**ADDENDUM NUMBER 1 ON INVITATION TO BID ITB18KO-131**

**TITLE:** Building 700 Renovation – Phase 2

CONFORMANCE  
DOCUMENTS

CHANGES THIS SHEET FROM 100% CONSTRUCTION DOCS:

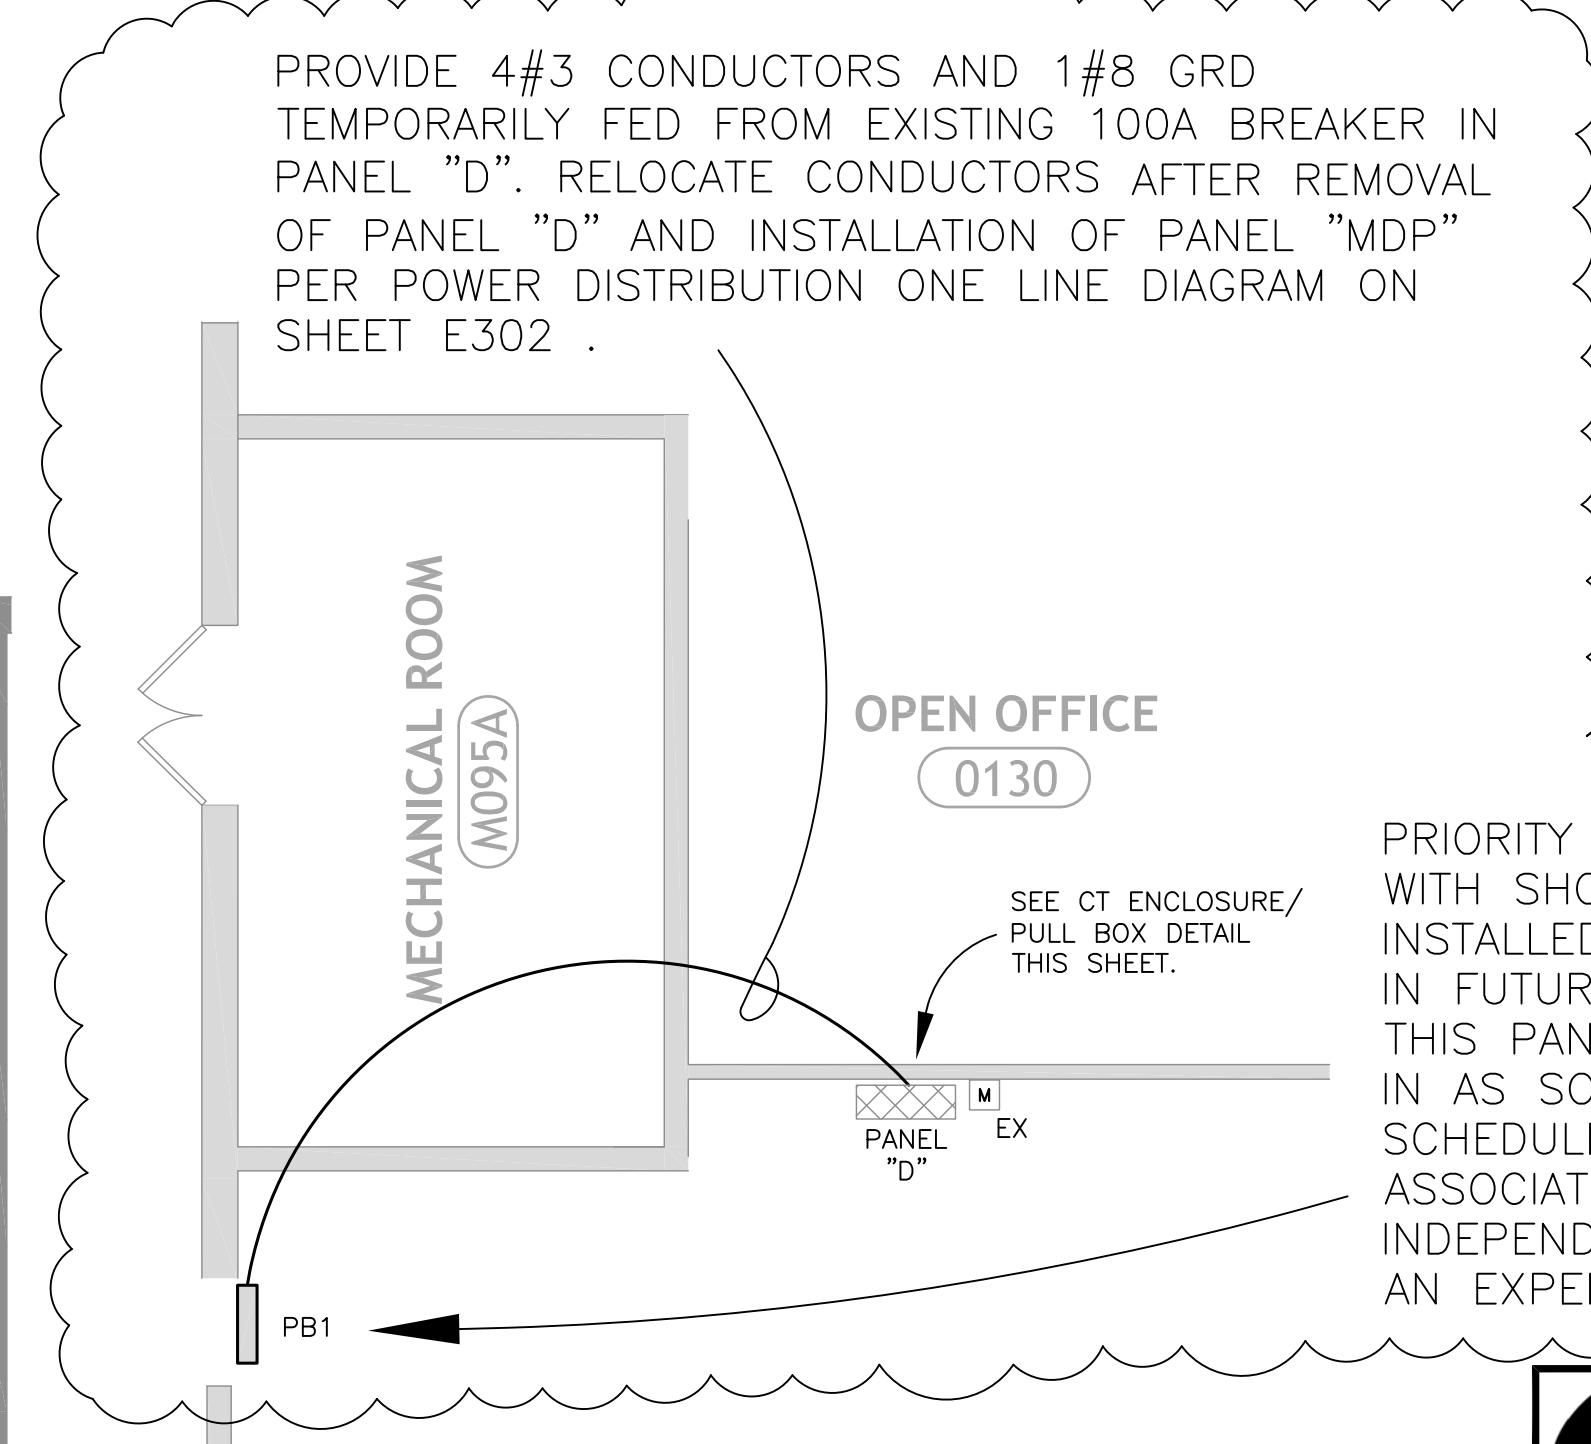
- EAST & WEST WING SECTIONS OF BUILDING ADDED TO DEMOLITION SCOPE.
- NOTES PERTAINING TO SCHEDULING PRIORITIES ADDED. CONTRACTOR SHALL COORDINATE EXACT SCHEDULING WITH OWNER PRIOR TO PRICING.
- CT ENCLOSURE/PULL BOX DETAIL ADDED.

**E201**  
ELECTRICAL POWER FLOOR PLAN

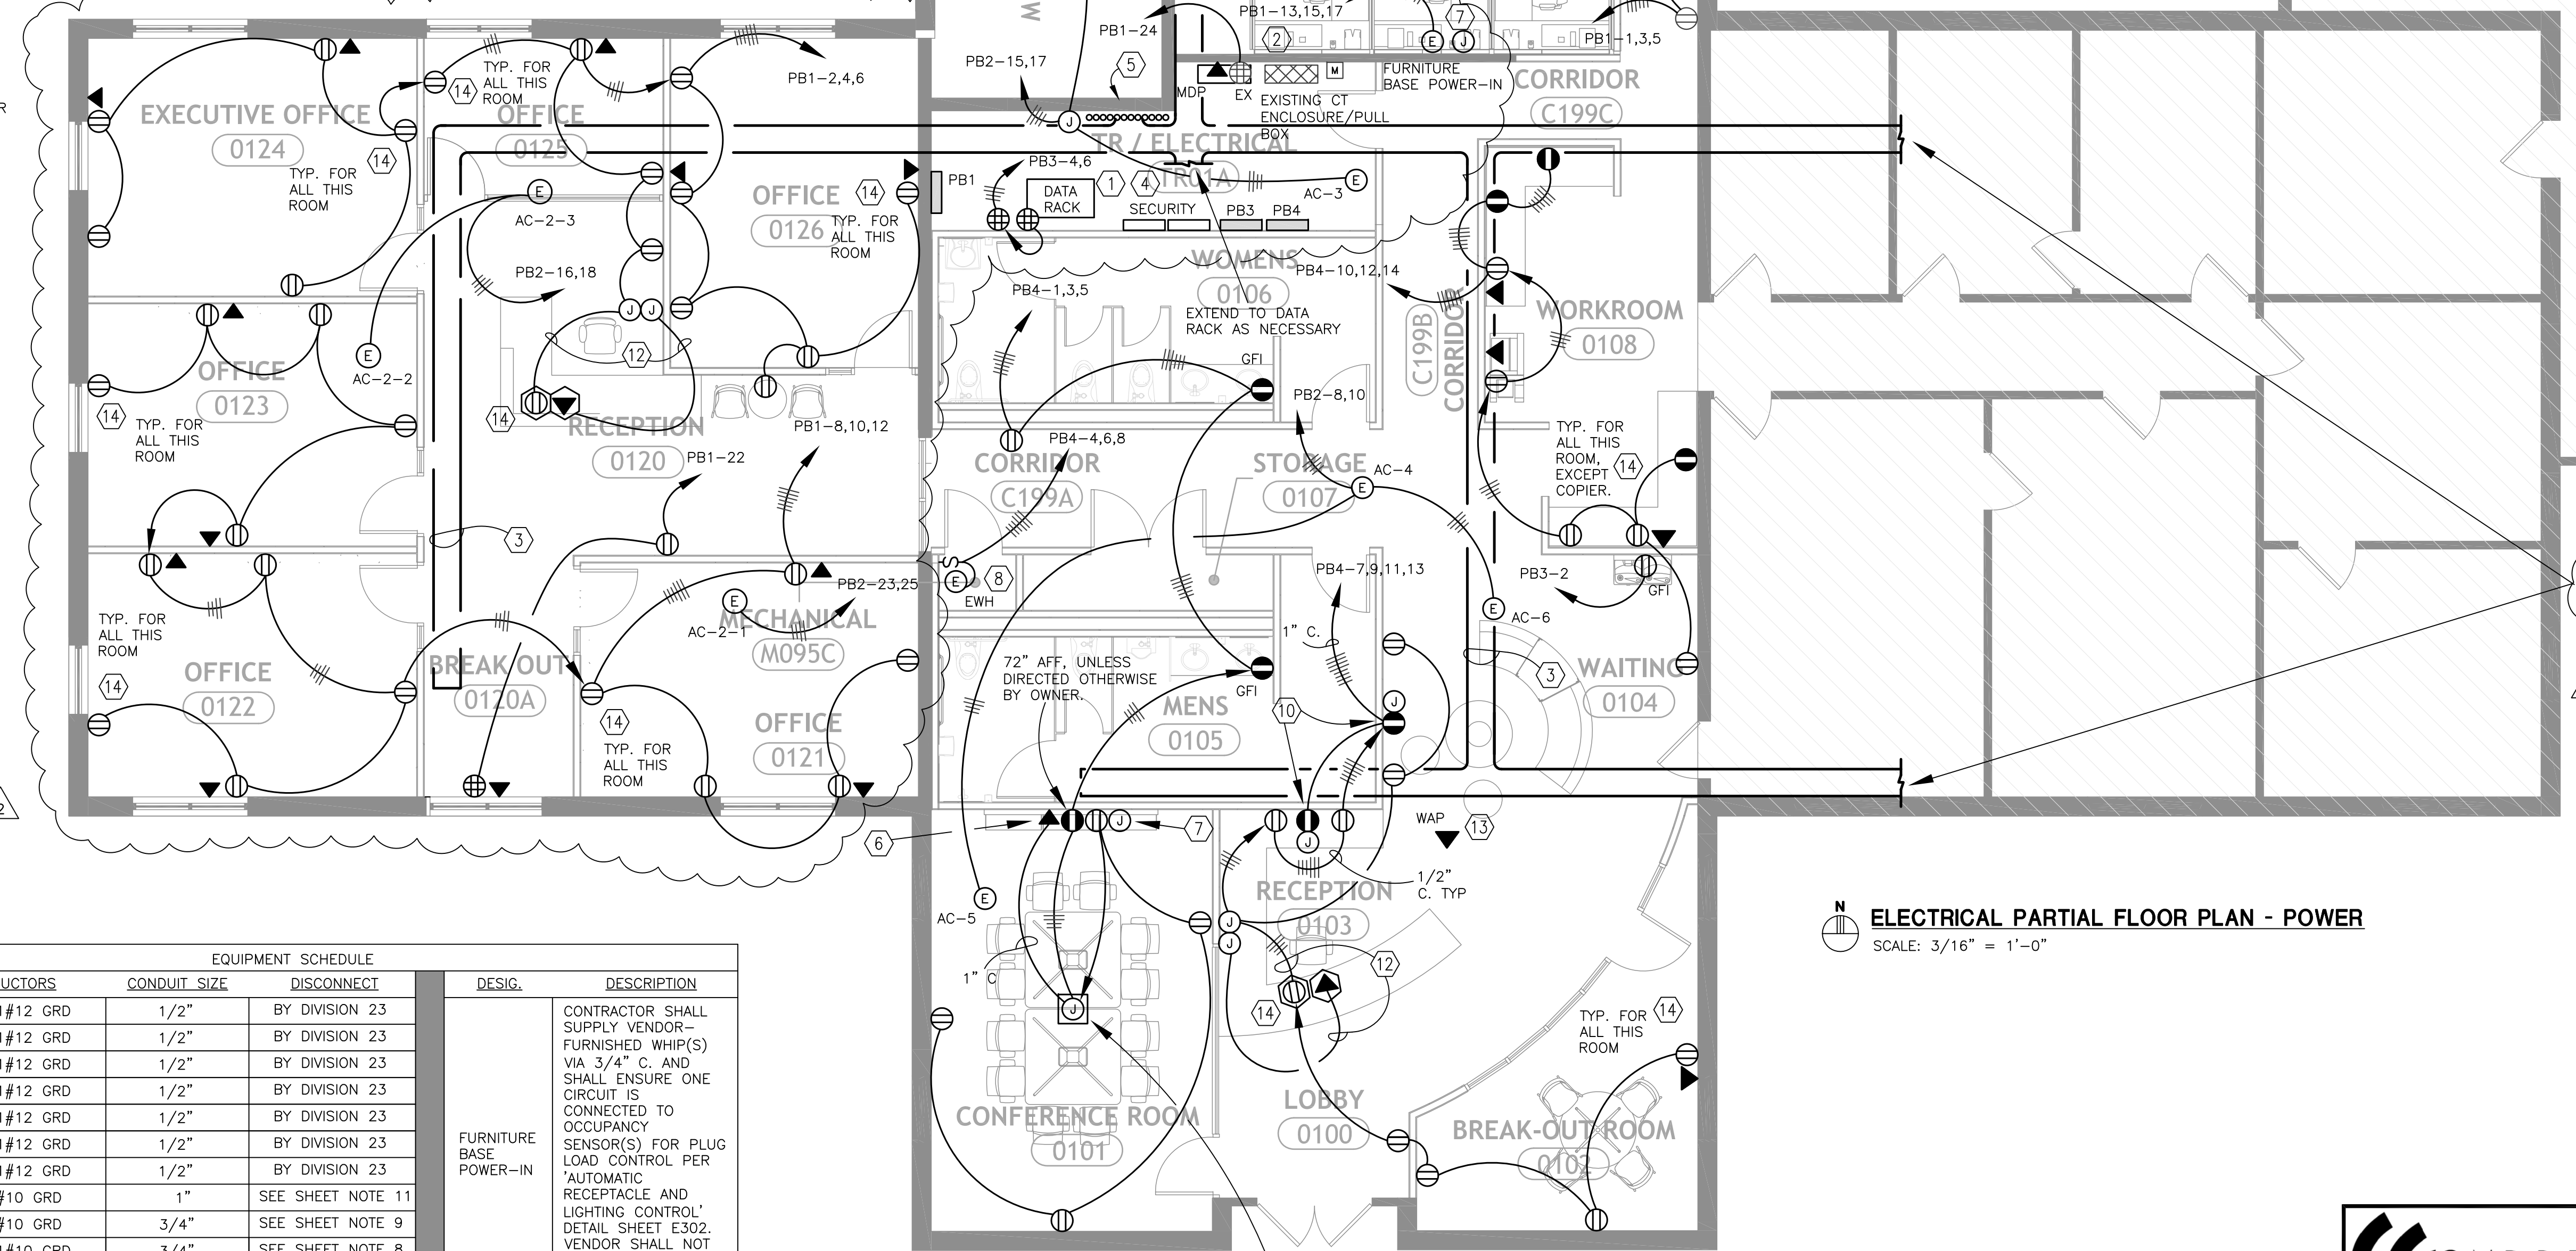
- DELETED FIRE ALARM DEVICES.
- DELETED RECEPTACLES MOUNTED IN MILLWORK IN OFFICE 130.
- ADDED EQUIPMENT CONNECTIONS FOR FURNITURE BASE POWER-INS IN OFFICE 130.
- RECONFIGURED CIRCUITING.
- ADDED PANEL 'PB4'.
- RECONFIGURED CU-A,B SUPPLY SIZE.
- ADDED NOTES TO AUTOMATIC RECEPTACLE AND LIGHTING CONTROL DETAIL.
- POWER AND DATA TO WEST WING SECTION OF BUILDING ADDED TO SCOPE.

**E202**  
ELECTRICAL  
LIGHTING FLOOR  
PLAN

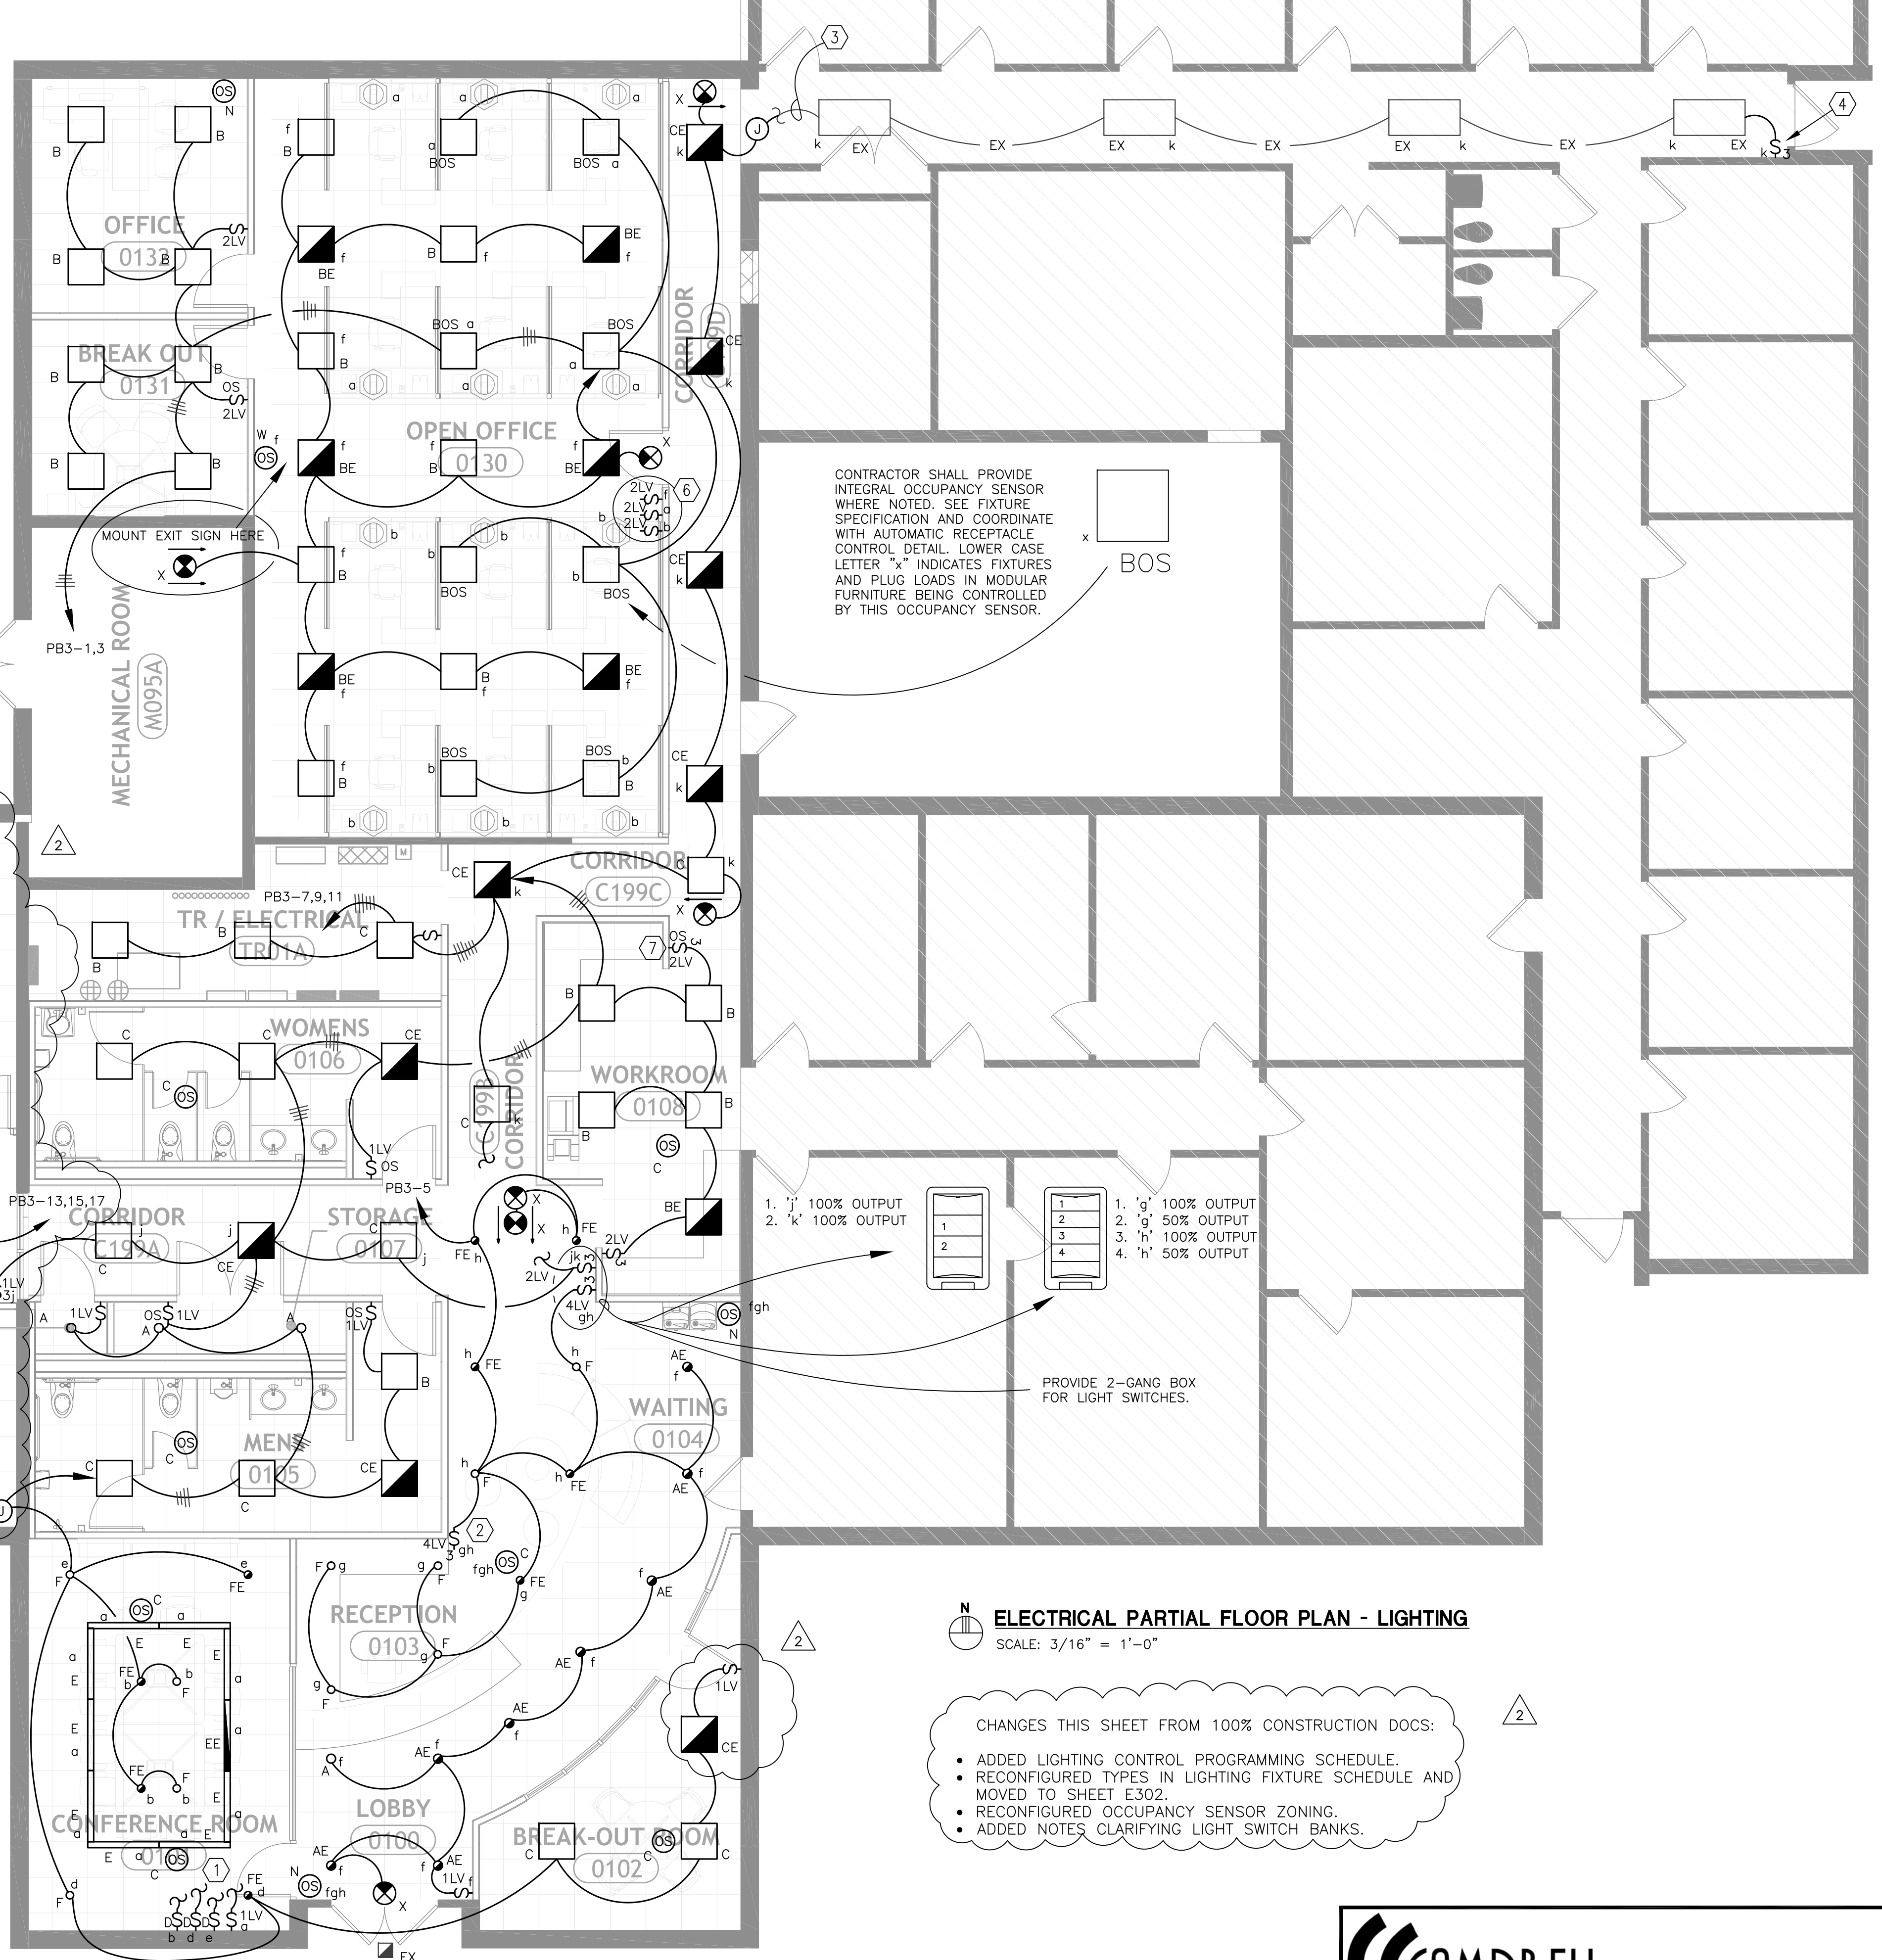
- ADDED LIGHTING CONTROL PROGRAMMING SCHEDULE.
- RECONFIGURED TYPES IN LIGHTING FIXTURE SCHEDULE AND MOVED TO SHEET E302.
- RECONFIGURED OCCUPANCY SENSOR ZONING.
- ADDED NOTES CLARIFYING LIGHT SWITCH BANKS.
